Service Kit

Title: Bell 429 Air Conditioner Relay Box update

Date: 27 August 2015 (Rev A)

Applicability: Bell Helicopter Model 429 Equipped with the Air Comm Corporation 429EC-200 and -202 Air Conditioning Systems

429EC-8424-2 Relay Panel
Schematic (Modified with Bridge Diode)

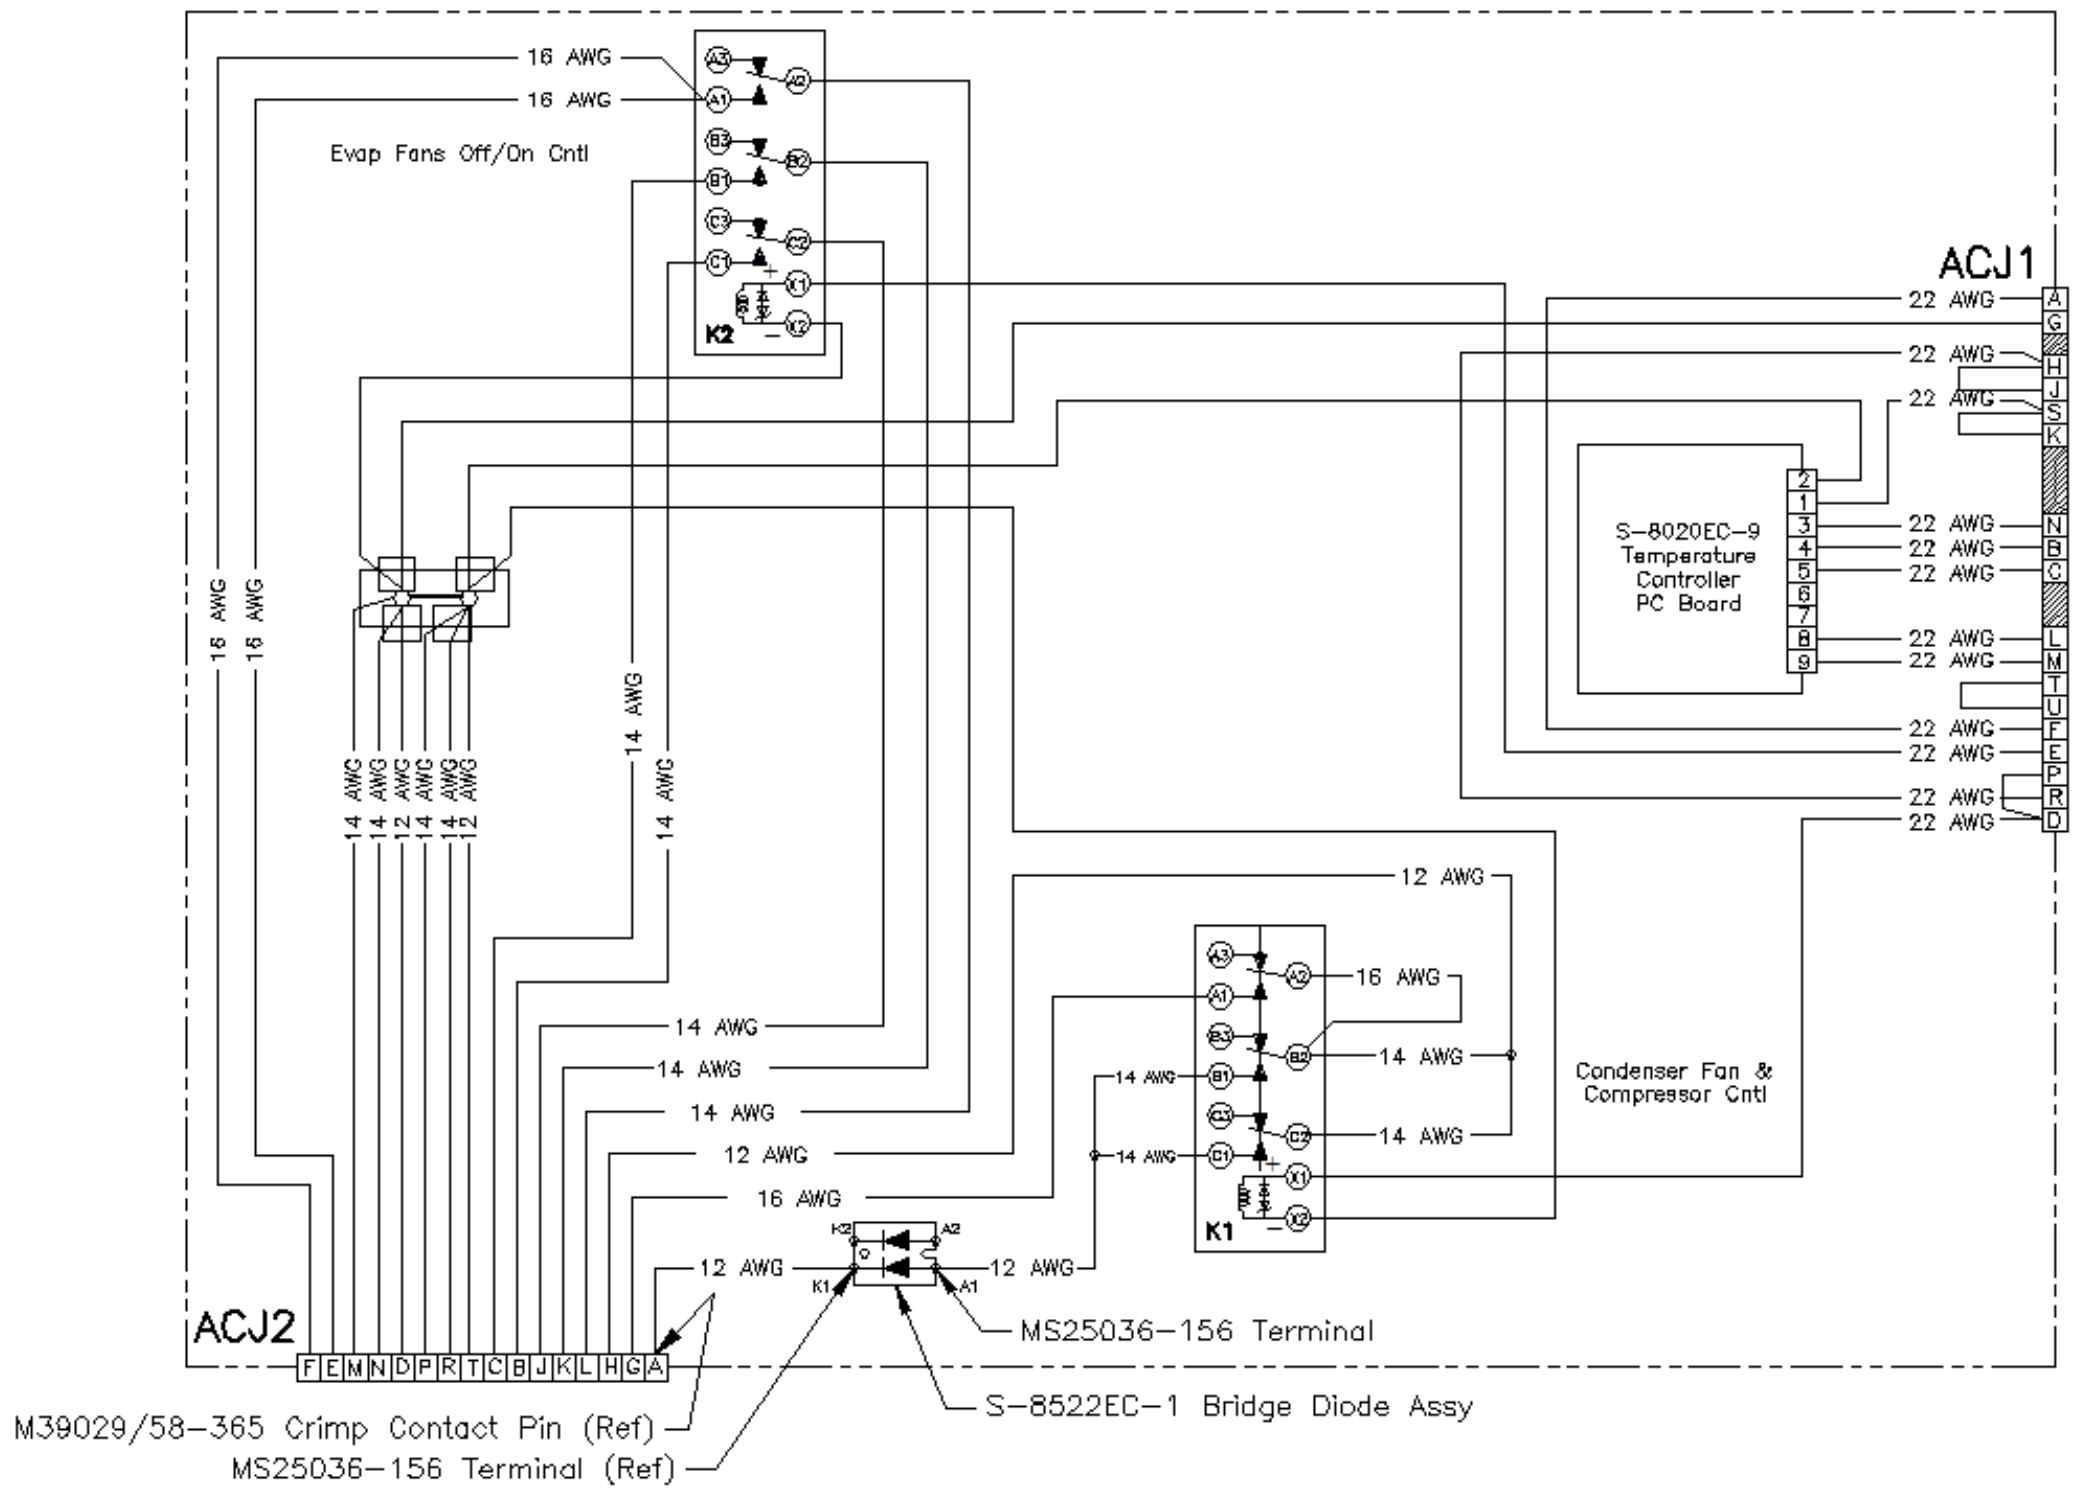
In rare cases, an anomaly may occur when the non-essential (NE) bus de-energized (possibly due to an OEI event) and the aircraft is in forward flight with the air conditioner operating. Under certain conditions, the ram air flowing through the condenser may rotate the blower motor causing a small voltage to be generated and applied to the bus which prevents some NE bus loads, including the indicator light, from de-energizing. The potential for occurrence is greater at higher forward airspeeds.

This Service Kit provides the instructions and list of components for modifying the air conditioning system relay panel box to alleviate this issue. The modification adds a blocking diode into the condenser blower circuit and can be obtained for no charge from the service department at Air Comm corporation. Please contact us at: Phone 303-440-4075, Fax 303-440-6355, or E-mail service@aircommcorp.com

- 1.1 Access the AC Relay Panel (shown below) labeled 429EC-8424-2 and remove the cover (3 phillips head screws). Note that the modification can be done with the Relay Panel in place, although removing the box will simplify the updates.

- 1.2 Modify the relay panel box per the schematic and the instructions in steps 1 thru 4 in the figures below.

- 1.3 Re-install the relay box. Mate the harness connectors to the relay box and verify the evaporator blowers, the compressor clutch and condenser blower functions.
